JLRTB02107NAS1

TECHNICAL BULLETIN

308-07B

Whining Noise From Transfer Case

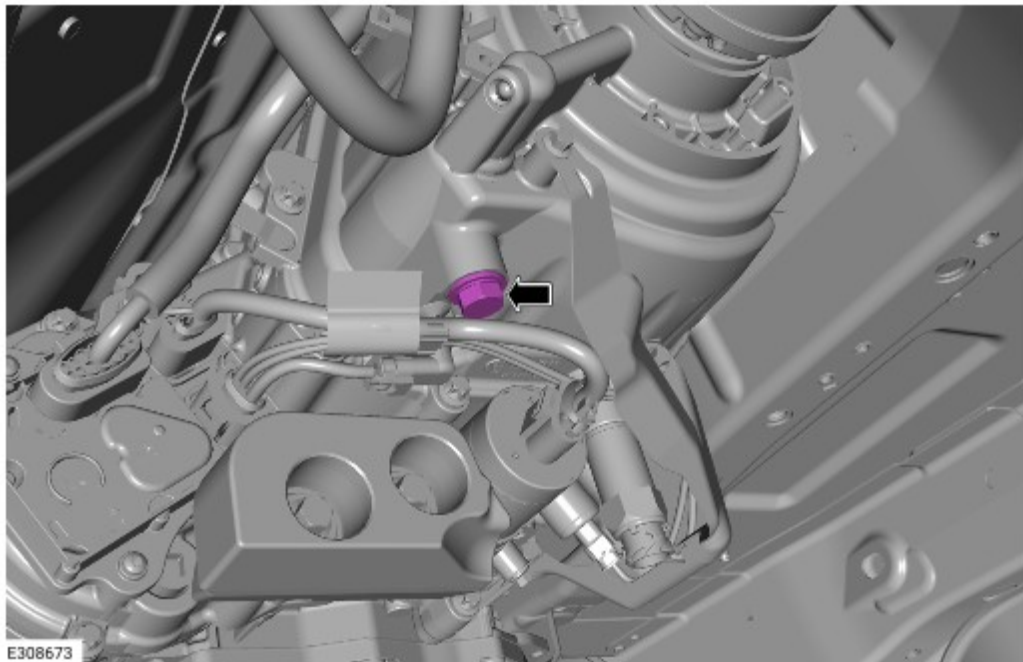
A whining noise can be heard coming from the transfer case between 20 to 30 mph (30 to 65 km/h) after third gear has been engaged.

Noise transfer through the selector fork.

Remove the transfer case detent pin.

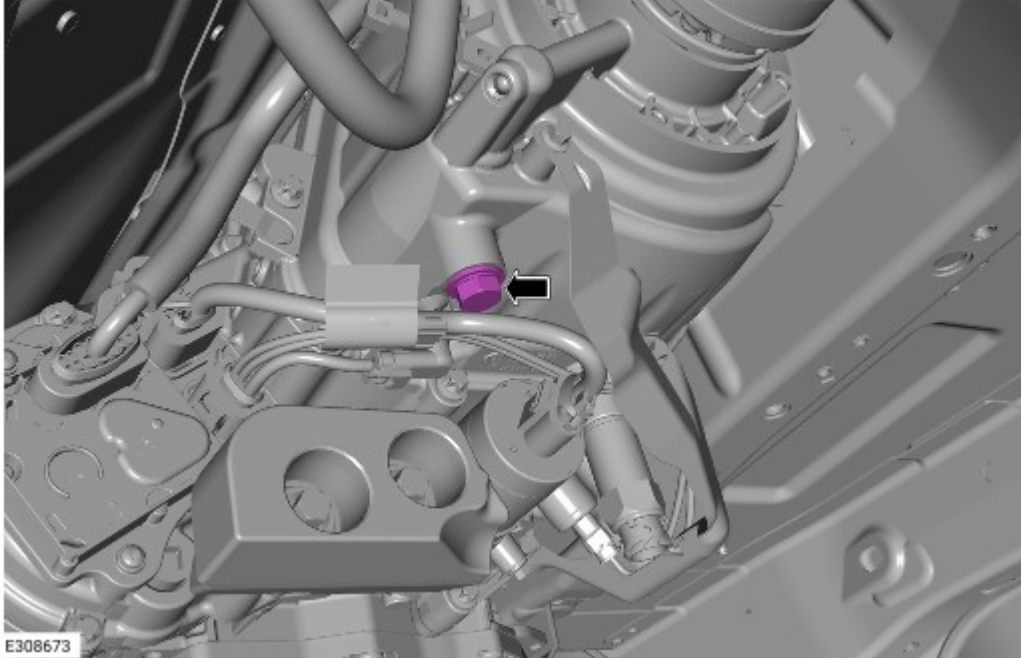
The threads of the new transfer case detent pin are pre-coated with thread lock. Do not apply additional thread lock.

Install the new transfer case detent pin.

- Torque: **20 Nm**
